IN THE DRAWINGS

In accordance with the Response pursuant to 35 C.F.R. § 1.111 filed herewith, Applicants respectfully request approval to amended Sheets 1 and 2 of the drawings as follows:

Attorney's Docket: 064731.0143 USSN 09/588,806 filed 06/06/2000 For: Transport Network and Method By: Mo, et al. SEP 1 9 2003 Sheet 1 of 9 REPLACEMENT SHEET PORT 000 PORT PORT 000 34 PORT **PORT** PORT 000 000 38 PORT 000 32 32 34 **PORT** PORT 000 000 000 30~ 62 ETHERNET SWITCH ETHERNET SWITCH 52 9. 30 FR SWITCH PORT PORT PORT 000 000 $\frac{6}{2}$

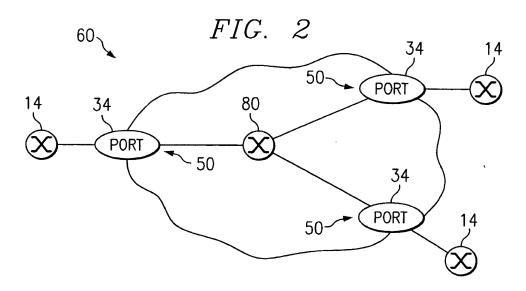
The drawings filed on June 6, 2000 stand objected to by the Examiner as failing to comply with 37 C.F.R. § 1.84(p)(5) because they do not include reference signs 12, 50 and 52 mentioned on pages 13-15 in the disclosure. Figure 1 is objected to because reference number 32 (far right, top) points to the dotted line of item 64 instead of the sold line representing an inter-nodal link.

Replace Sheets 1 and 2 of the drawings originally filed with the Application with the Replacement Sheets 1 and 2. Replacement Sheets 1 and 2 contain amended FIGURES 1 and 2. It is submitted that no new matter is added by the amendments.
